APPROVED MINUTES OF THE MEETING

March 18, 2010

Alaskan Way Viaduct Replacement
Streetcar Network

March 18 2010	Project:	Alaskan Way Viaduct Replacement
	Phase:	Design Update
	Last Reviewed:	Feb 18, 2010; Jan 21, 2010; Oct 1, 2009; Jun 18, 2009; May 21, 2009; Jan 15, 2009; Oct 16, 2008; Aug 21, 2008; Jul 3, 2008; Apr 3, 2008; Dec 20, 2007; Oct 18, 2007; Oct 4, 2007; Apr 19, 2007; Nov 2, 2006
	Presenters:	Boris Dramov, Roma Design John Savo, NBBJ
	Attendees:	AJ Yang, Chinatown ID PDA Amy Williams, NBBJ Bob Corwin, Citizen Bonnie Fisher, Roma Design Brian Steinburg, Allied Arts Casey Hildreth, SDOT Cela Fortier, GHD Christi Skinner, HDR Engineering Christina Bollo, Pedestrian Advisory Board Darby Watson, SDOT David Skinner, HDR Engineering David Yuan, NBBJ Diane Hilmo, WSDOT Emily Mannetti, Enviroissues Eric Tweit, SDOT Jeffrey Bailey, NBBJ John White, WSDOT Lloyd Douglas, Cascade NC Mike Johnson, SDOT Ruri Yampolsky, Arts and Cultural Affairs Steve Leach, WSDOT Steve Pearce, SDOT Susan Everett, WSDOT Vaughn Bell, SDOT

South Portal Vent Building (top) and Arrival (Bottom)

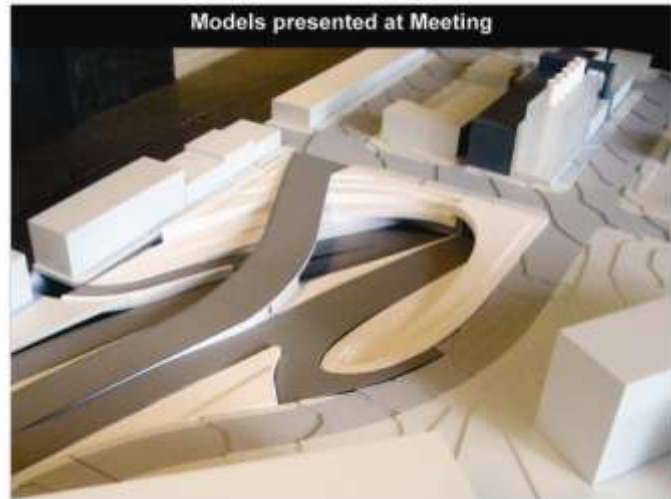
- **The Commission likes the idea of the pedestrian zone that leads to the waterfront. Think further about how the landscape will be incorporated.**
- **Perhaps explore a hybridization of the “Camo” and “Strata” design concepts of the support buildings as they will have significant ramifications on the pedestrian experience.**

Perhaps a hybrid of the strata and camo approach might be needed at the north portal due to the variety of architecture styles in the area. A volumetric approach is appealing.

I think there's strong exploration and we appreciate it. The renderings have helped to envision this. I want to reinforce our preference for the strata. There's an inverse pedestrian experience. It seems like there needs to be more intentional exploration around the edges. What kind of textural quality does this have with the light and dark? The terracing and such is good but the strong edges are going to confine movement. There's a lot of promise but you can tie the DNA together. At the north, there is a building and a landscape; maybe the two can be blended.

I think that when we think about what's happening in that area, there will be some more pedestrians than we see today. I think the concrete and its permanence; I would like to see materials that are more engaging. The appeal with the camo is the ability to play with the transparency and depth and layers and enhances variety. I wonder if it can inform the activity across the street. There are some tremendous view opportunities there at the street, maybe there is a relationship that can happen at the oval and a feature can take place which connects what's below with what's above. That whole fencing thing will be tricky as a big fence does not seem appropriate.

I want to disagree with the rest of the Design Commissioners. The volumes and the form in the camo scheme are a much stronger move in the context of the interchange. A building with such stark monumentality has an ability to foil with the landscape design and it can be an interesting thing to be discovered at the pedestrian level. Big vote for camo.
